Deadline 1 submission – from James Hewitt

This submission questions the area of land-take proposed and what an approved DCO would entitle the Applicant to do.

[The chart is a copy of Figure 3 of “*Carbon capture from energy-from-waste (EfW): A low-hanging fruit for CCS deployment in the UK?*” by The Oxford Institute for Energy Studies dated May 2024.]

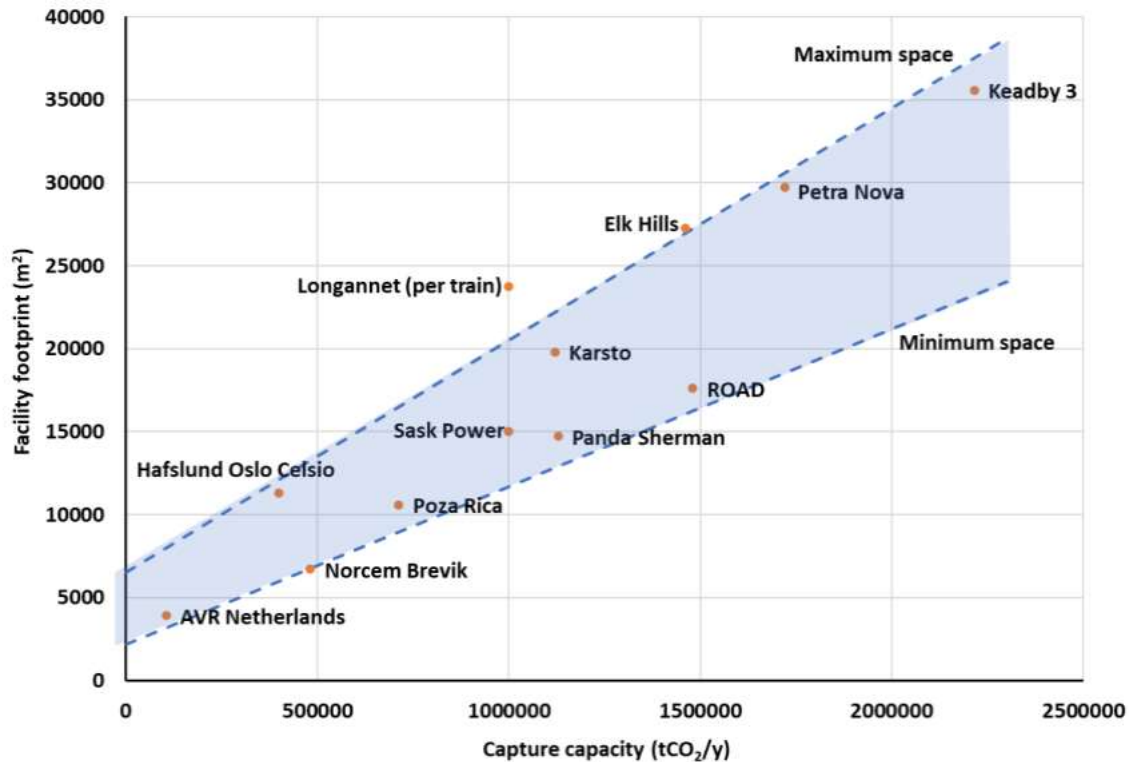
1 - Further to the hearings between the 5th and 7th of November, the following chart reinforces the view that the land-take sought by the Applicant is well in excess of need. If the proposed project were to capture 1.7 million tonnes of CO₂ in a year [see Note 1 below], the chart indicates that the land take required is unlikely to exceed three hectares – less than half the eight hectares which the Applicant asserts is needed (Clause 6.6.2 in “*Statement of Reasons*”). §
